# **ADDENDUM NUMBER 2**

**CITY OF CORCORAN**

**GATEWAY PARK**

**September 13, 2021**

GR-1.02

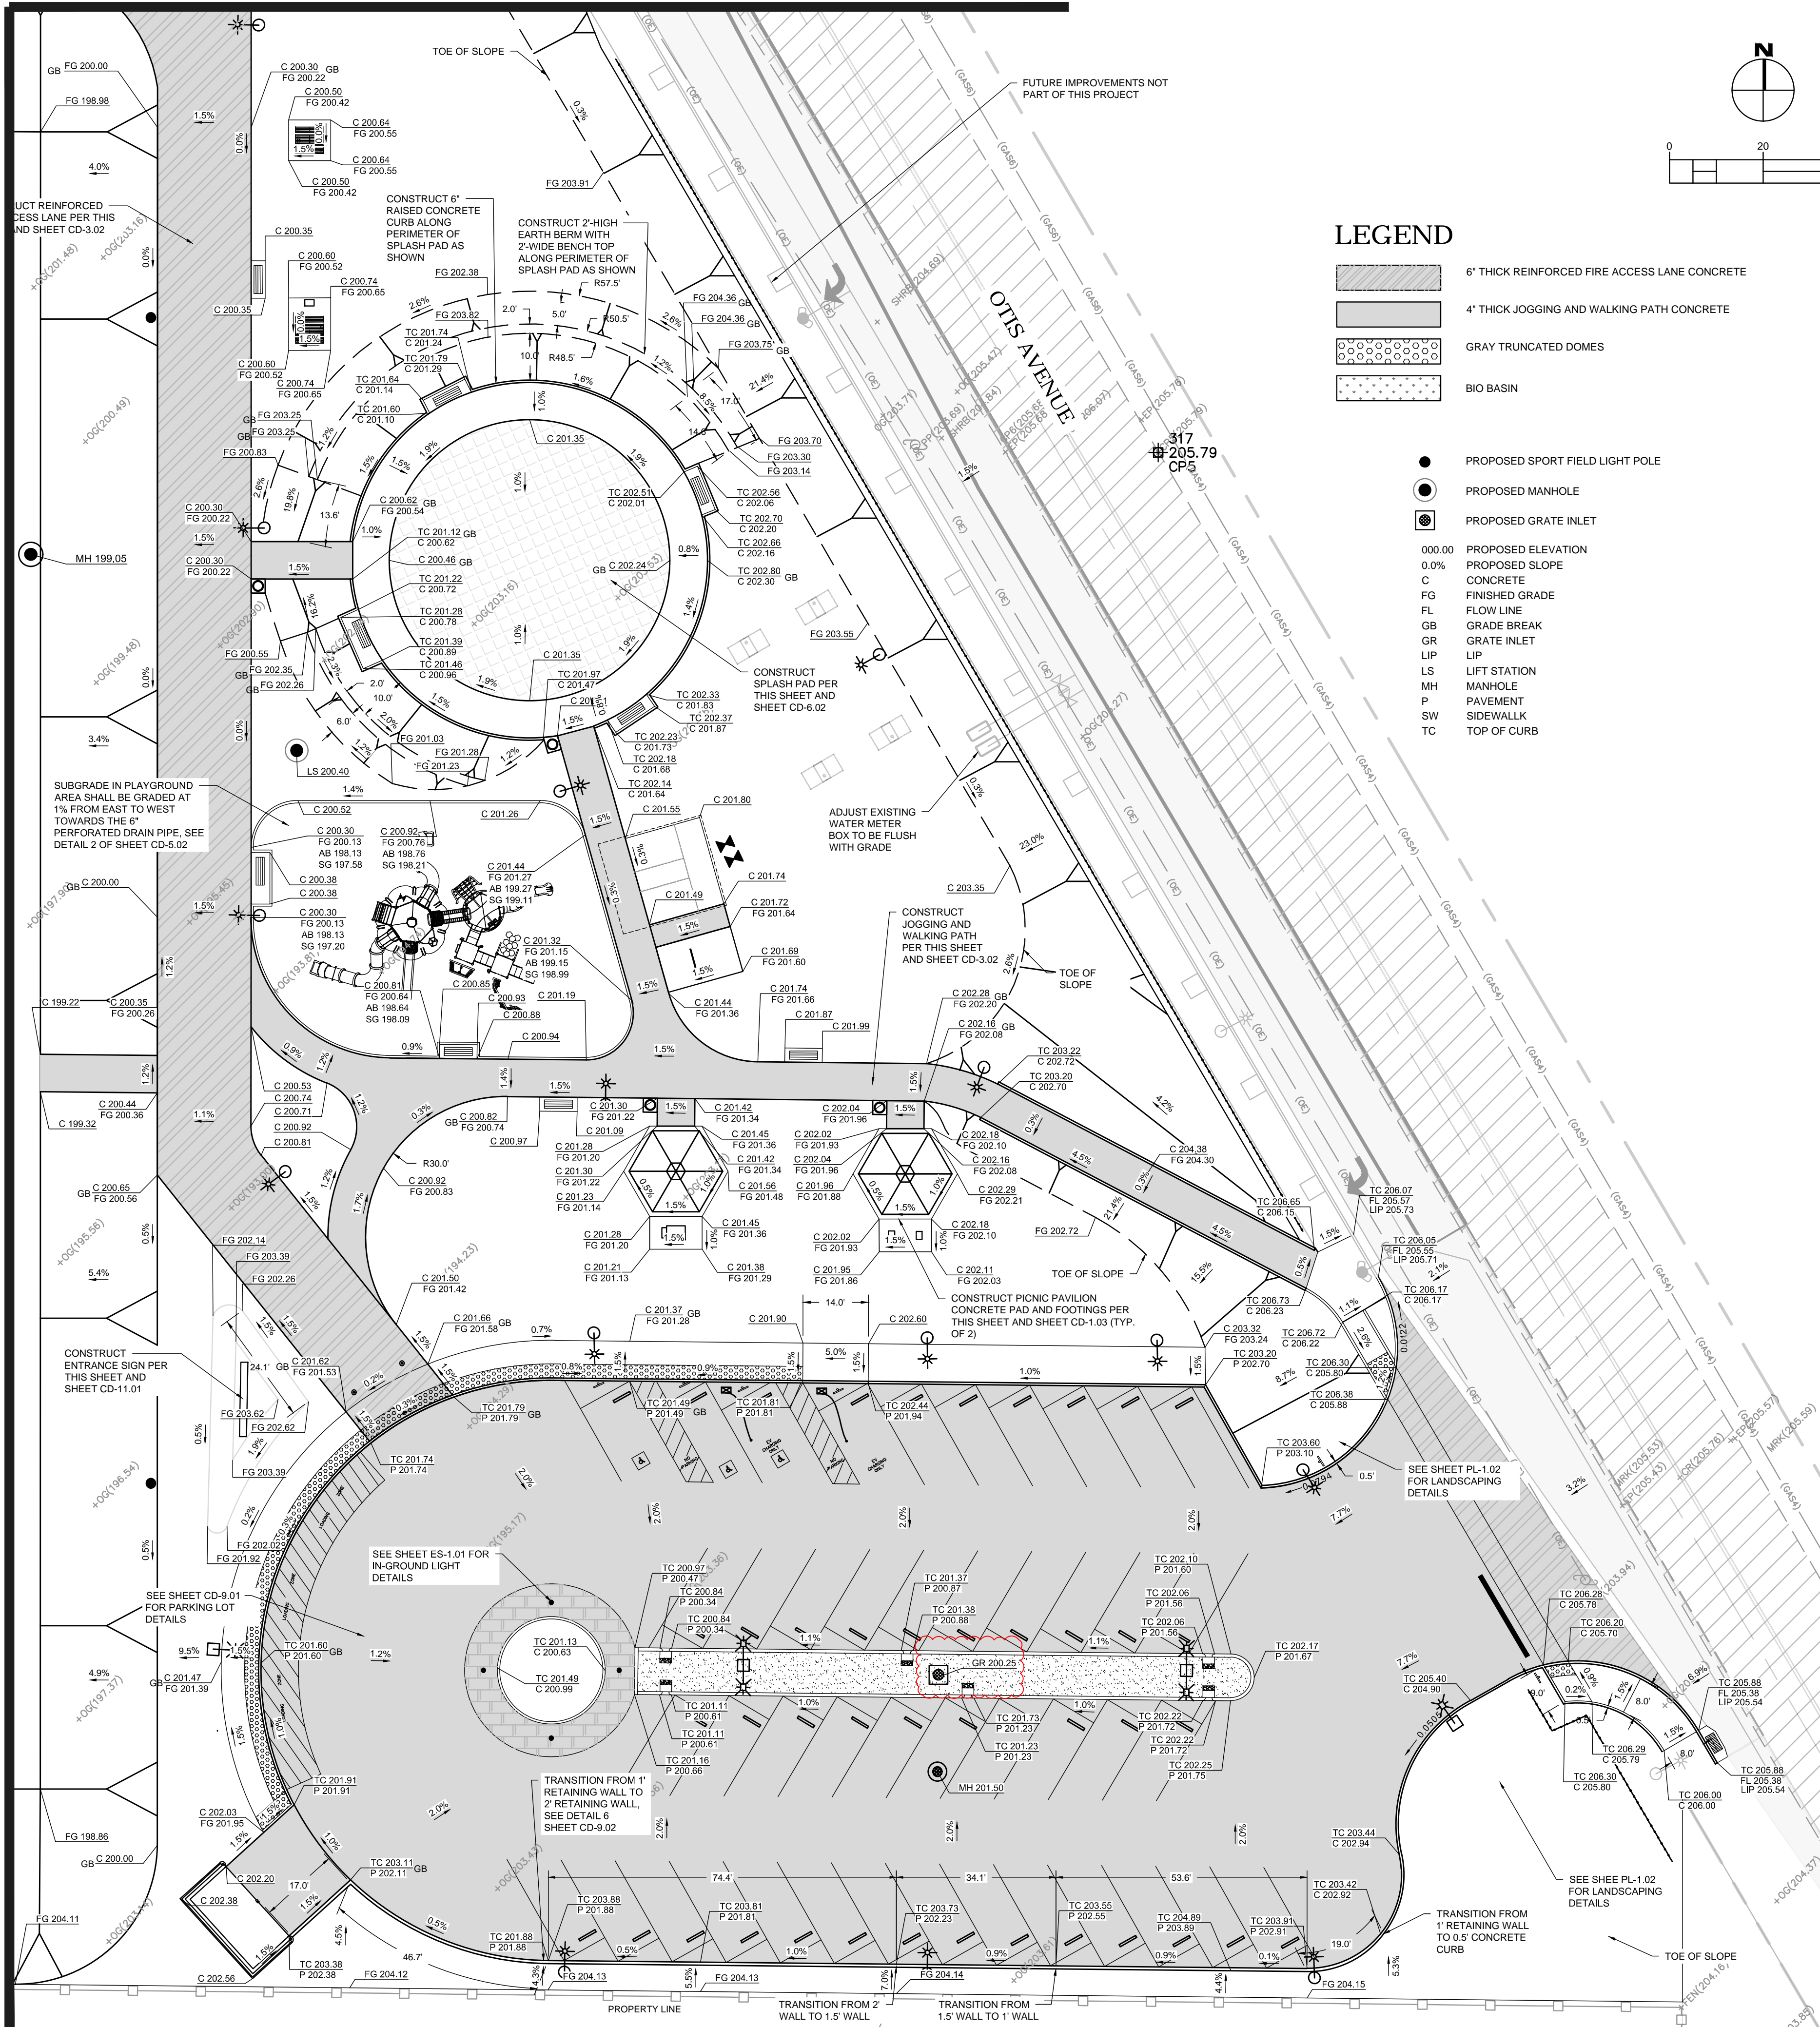
Replace sheet GR-1.02 with the attached sheet GR-1.02. grade at grate has been revised.
